Las Posas Valley Groundwater Basin Technical Advisory Committee Regular Meeting

**Watermaster Committee Consultation on the Las Posas Valley Basin, Basin
Optimization Yield Study Numerical Modeling Results, August 29, 2025**

RECOMMENDATION REPORT

Re: Recommendation Report – Las Posas Valley Basin, Basin Optimization Yield Study Numerical Modeling Results

Principal Area of West Las Posas Managment Area In-Lieu Deliveries

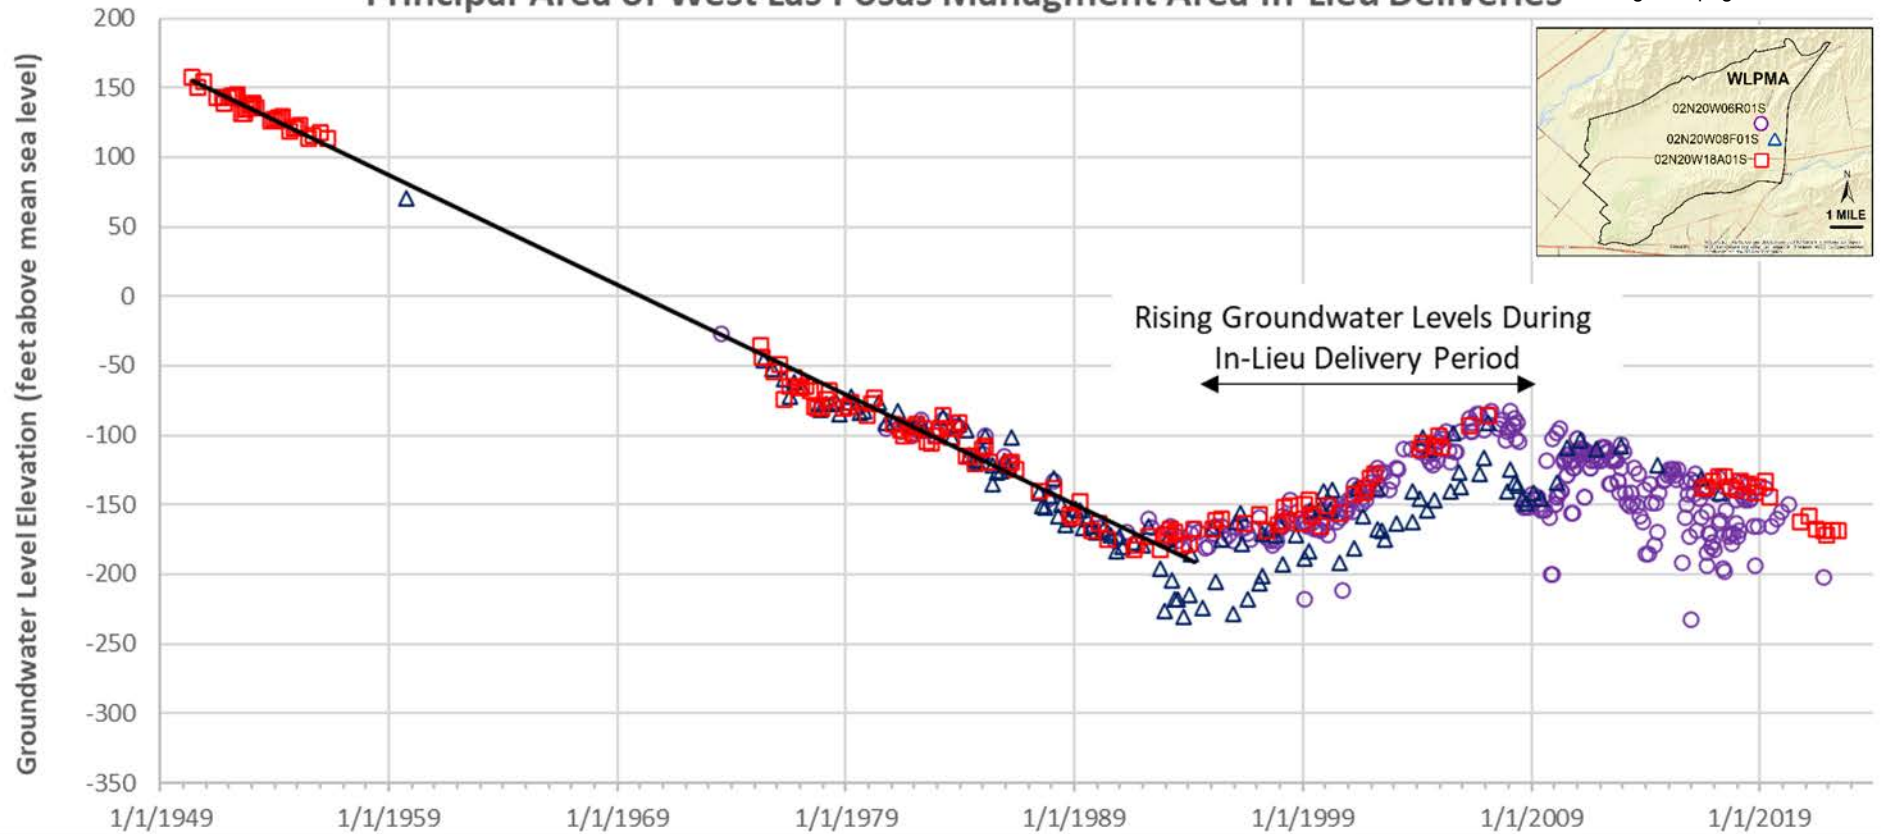
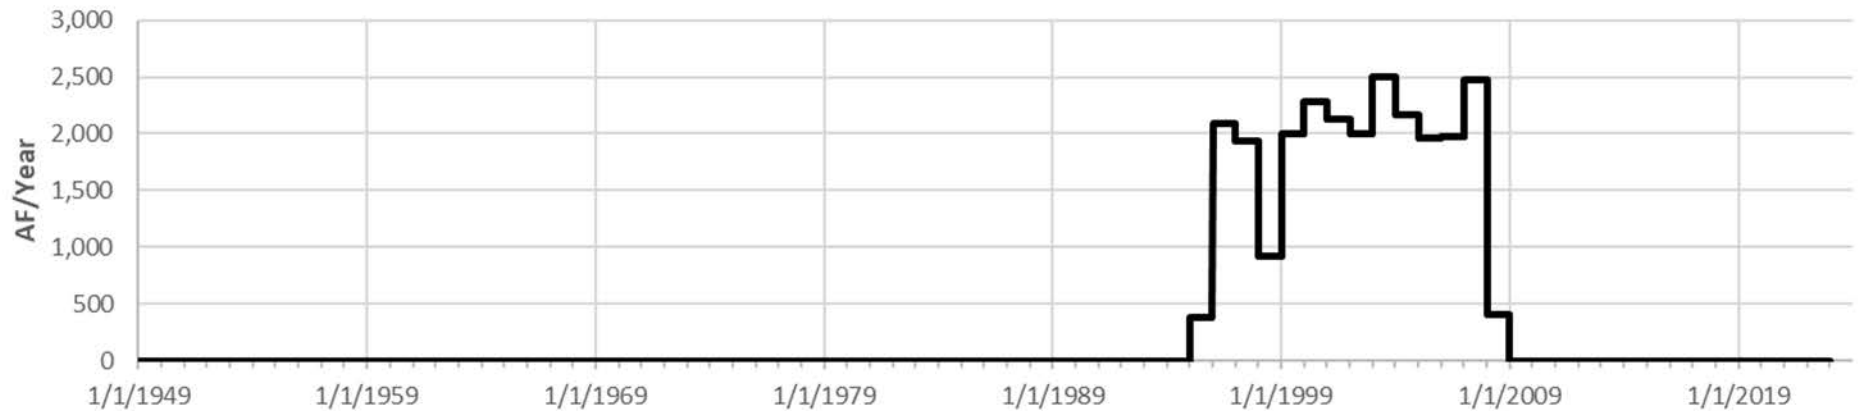
Mr. Bondy then showed the TAC a hydrograph of long-term groundwater levels with a period of decline followed by a period of recovery that corresponded with a historical in lieu delivery program. That historical in lieu was similar in volume to what is planned currently. Mr. Bondy indicated that despite the model results questions raised by the TAC, the historical data and operations should provide a level of comfort that the proposed project should have expected benefits. This graph is also included in Attachment 1.

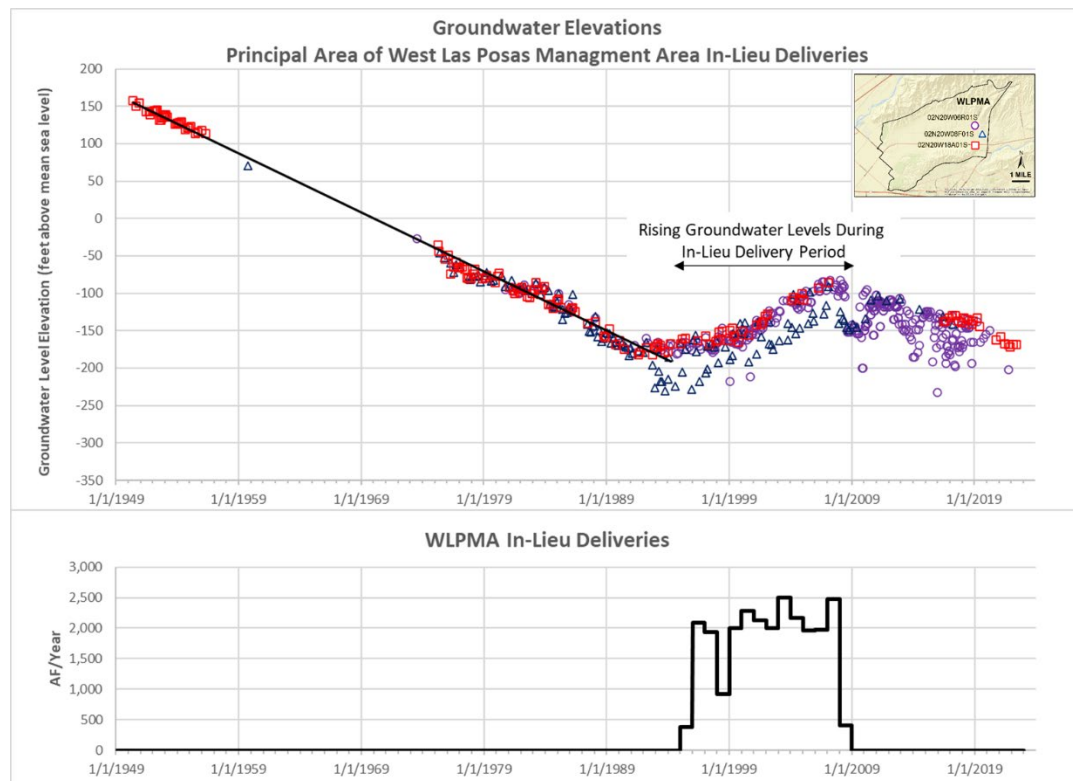
The West Las Posas Management Area (WLPMA) numerical model appears to significantly overestimate the amount of groundwater exchange between WLPMA and the East Las Posas Management Area (ELPMA). More than half of the volume of the simulated with-project in-lieu deliveries to the WLPMA were accommodated by a simulated change in flow between the management areas, which is inconsistent with the conceptual model of the boundary between the WLPMA and ELPMA. This suggests that the model may significantly underestimate the benefits of in-lieu deliveries to the area of the WLPMA to which the related project targeted. It also suggests that the benefits of implementing the project with the simulated volume of in-lieu water delivery may be greater than those simulated. As a result, the actual volume of in-lieu deliveries required to prevent water level minimum threshold exceedances in the WLPMA may be much lower than that simulated in the with-project model scenario.

Historical data demonstrates that a similar magnitude of in-lieu deliveries to WLPMA between 1996 and 2008 resulted in groundwater elevation increases of approximately 90 feet, as shown in the charts below.

The simulated change in groundwater elevations in wells near the WLPMA in-lieu project is much less than the historical observations. The four wells near the project showed simulated average groundwater elevation increases of around 7 to 17 feet. This comparison reinforces the observation that the model simulates WLPMA in-lieu deliveries leaving the management across what is agreed to be a no-flow boundary. As a result, the simulated in-

Include in the BOY Study report a detailed explanation of the differences between the baseline model results and the conceptual model at the boundary between the management areas. Also include descriptions of the simulated change in flow across the boundary in the simulation with an explanation of the potential differences between simulated and actual with-project conditions.
